Design Review Committee Meeting Agenda

Monday, June 10, 2024 at 5:00 PM

33 Church Street, Sutter Creek, CA 95685

ELEVATIONS

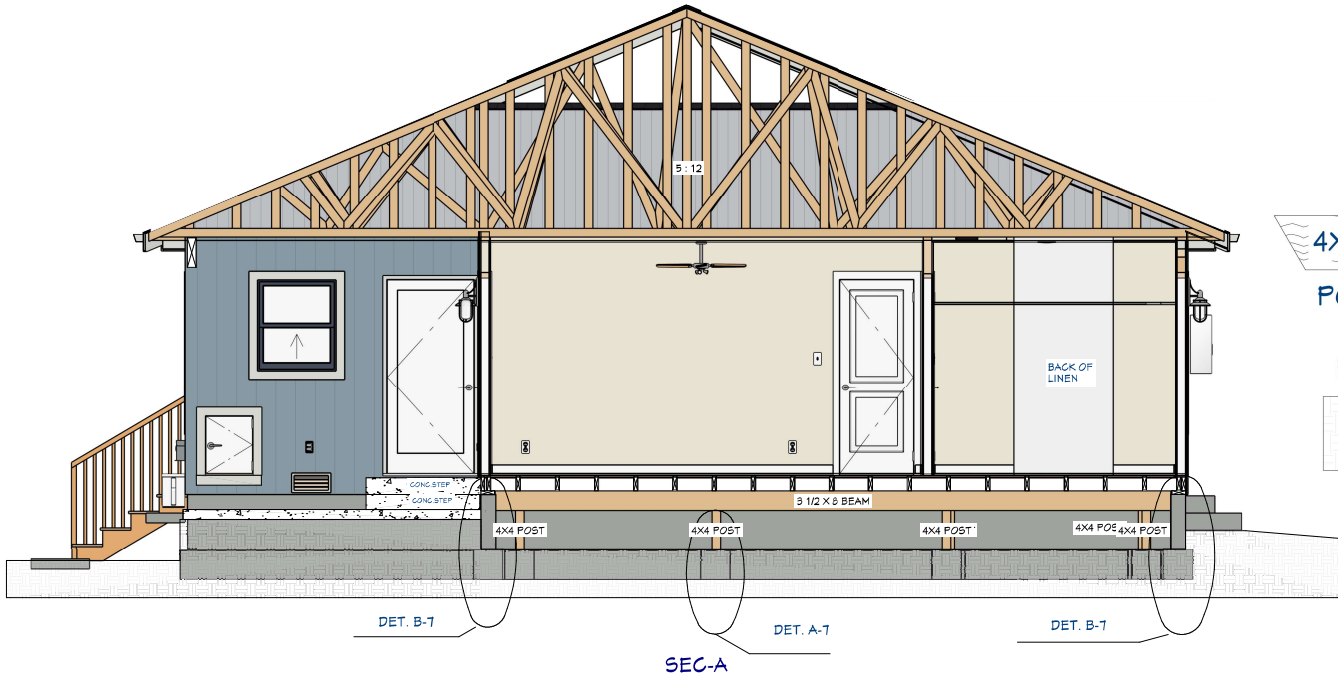
The applicant is proposing an interior remodel and addition to an exiting single family residence. The existing residence is described as Craftsman style by the applicant and they are proposing to continue with that style. The addition will match the existing siding on the house and they are proposing to replace the existing metal roof with a new metal roof.

In reviewing of the Design Standards the style of home may be more consistent with the National Style (Page 37).

2.3.2 Façade Design. The proposed windows and doors are in keeping with the Craftsman/National style of the home. A large front porch will be maintained.

2.3.8 Additions to Existing Structures. The addition to the existing structure is in keeping with the same style, scale, and proportion. The design of the addition incorporates the design of the existing structure.

3.5.3 Doors. The proposed door is in keeping with the Craftsman/National style.

Staff recommend that the Design Review Committee approve the proposed application as presented.

**Figure 1- Front Elevation
71 Main Street**

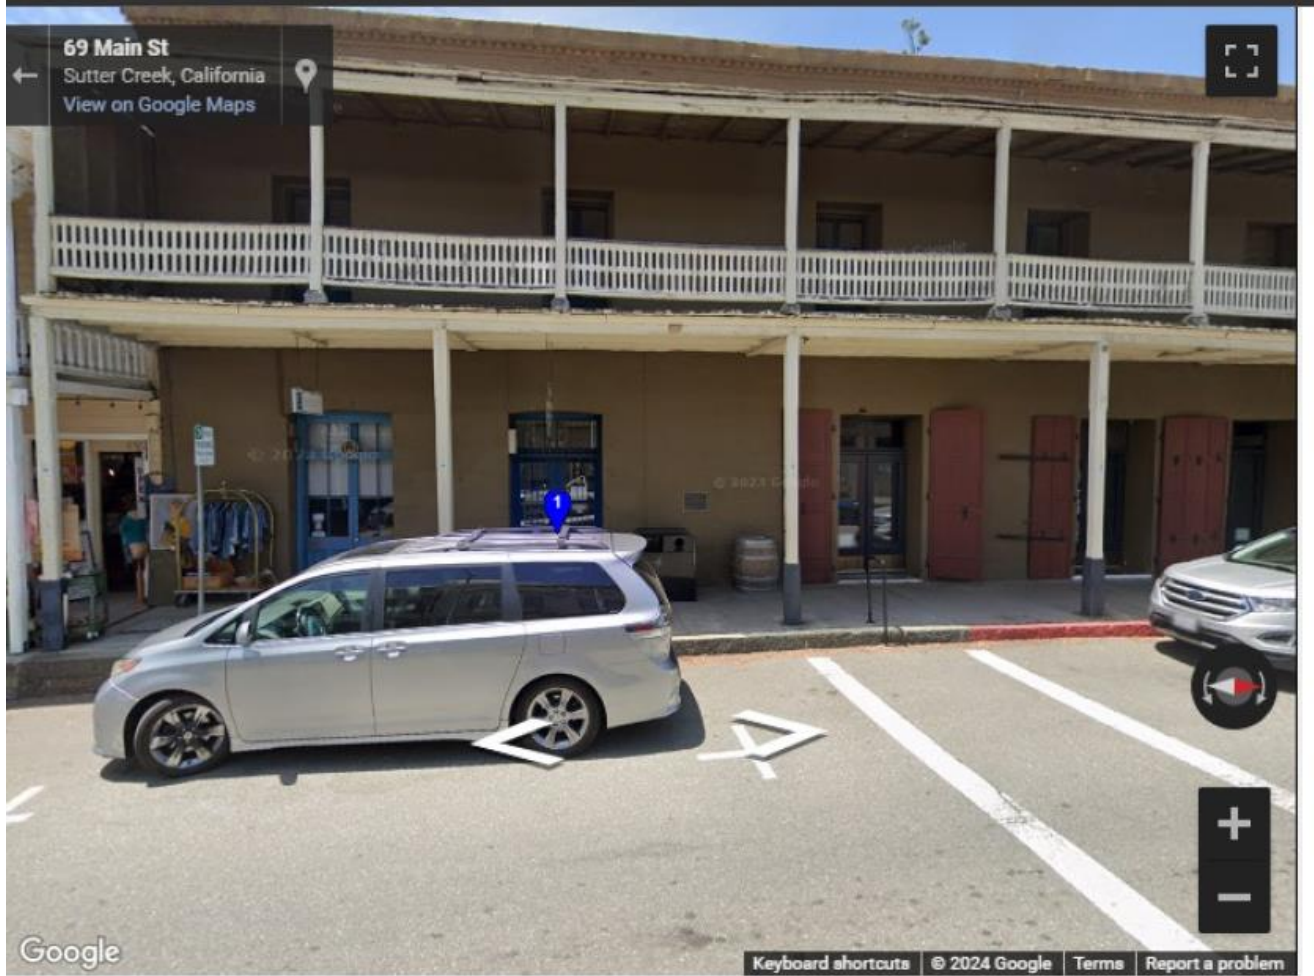
The existing wooden railing is in a state of disrepair. The applicant is proposing to redo the railing in the same style as it currently exists and is proposing to add a black metal pole below the decorative railing to increase the overall height of the guard to meet the 2022 California Building Code requirement of 42”.

The applicant is not proposing to change any of the historic features on the front of the building. The addition of the metal pole will not take away from the historical features of the existing railing.

Staff recommend that the Design Review Committee approve the proposed application as presented.

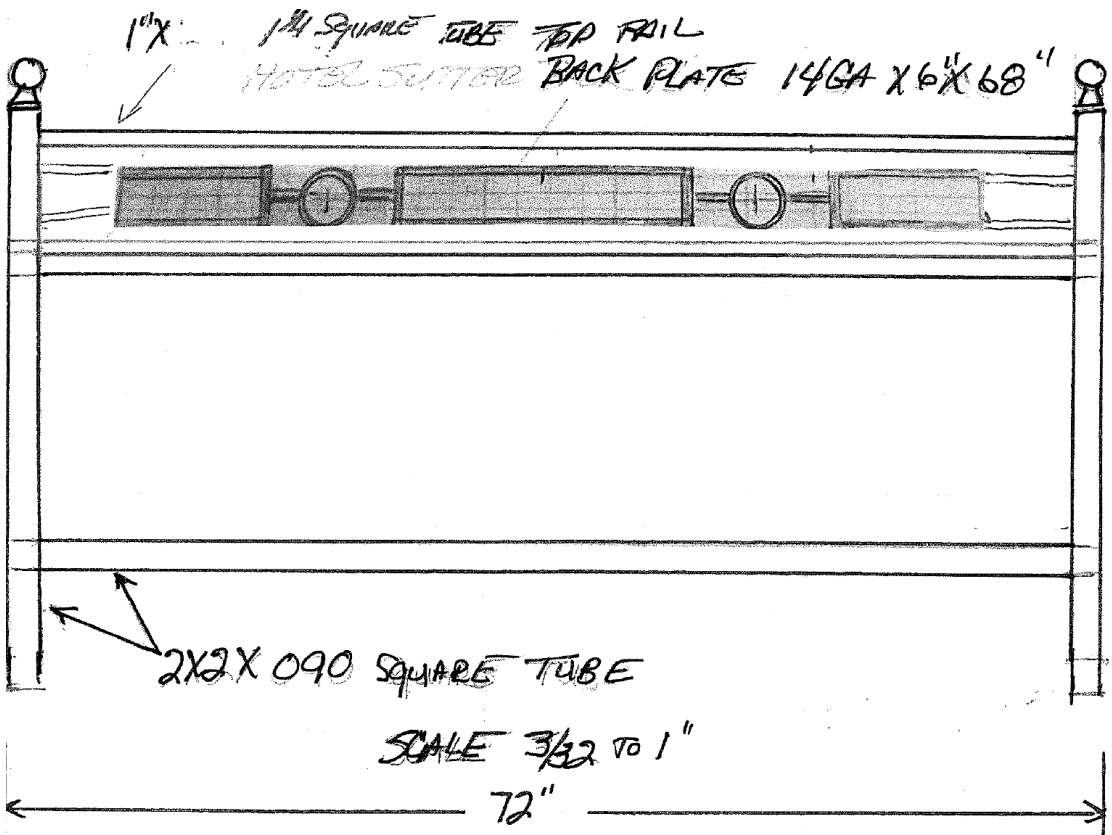
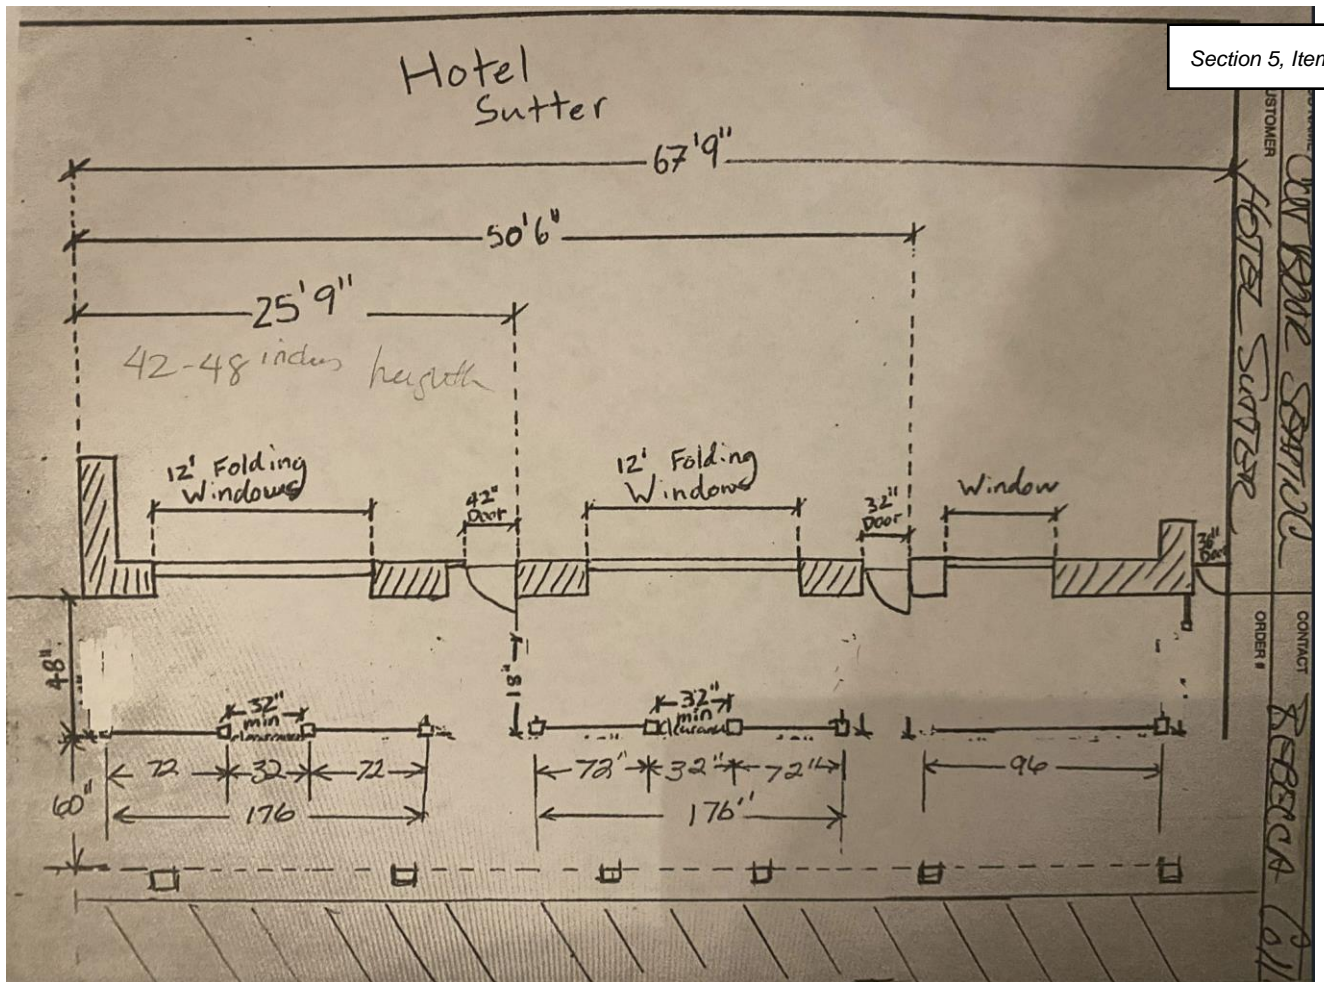
The applicant is requesting Design Clearance to install dark brown powder coated railings on the sidewalk on the front of the building. The proposed project would provide additional capacity for the restaurant and also provide an area for guests to dine outside on the sidewalk. Clearance will be maintained so that people on the sidewalk can still maneuver by. Five (5) feet is required to be maintained as a clear path for those walking on the sidewalk. The Building Department has reviewed the plans and is satisfied with accessibility.

The applicant is not proposing to change any of the historic features on the front of the building.

Staff recommend that the Design Review Committee approve the proposed design as presented. Once the applicant has Design Clearance the City Manager has the authority to issue an outdoor dining encroachment permit (Ordinance No. 371)
